GREENVILLE UTILITIES COMMISSION

QUESTIONS AND ANSWERS III FOR 25-55

RFB FOR MACGREGOR DOWNS REGULATOR STATION MATERIALS

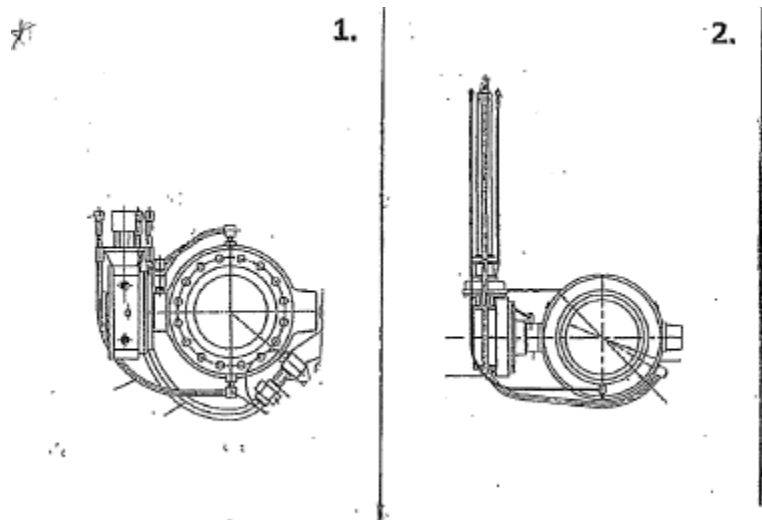
1. If I could get some clarification for LINE 3 / ITEM III:

4" Valve, Ball, Weld End, ANSI 300, Cameron T-31 or equivalent, Below Grade, Tarsel Coated, 1/4 Turn w/ 2" Nut, w/ Lubrication Lines, Lockable

PLEASE SPECIFY IF STUB UP EXTENSION (#1) OR A PINION SHAFT EXTENSION (#2)

(IF PINION SHAFT EXTENSION, WE NEED TO KNOW THE MEASUREMENT FROM CENTERLINE OF VALVE TO TOP OF 2" SQUARE NUT)

Option 1 above.
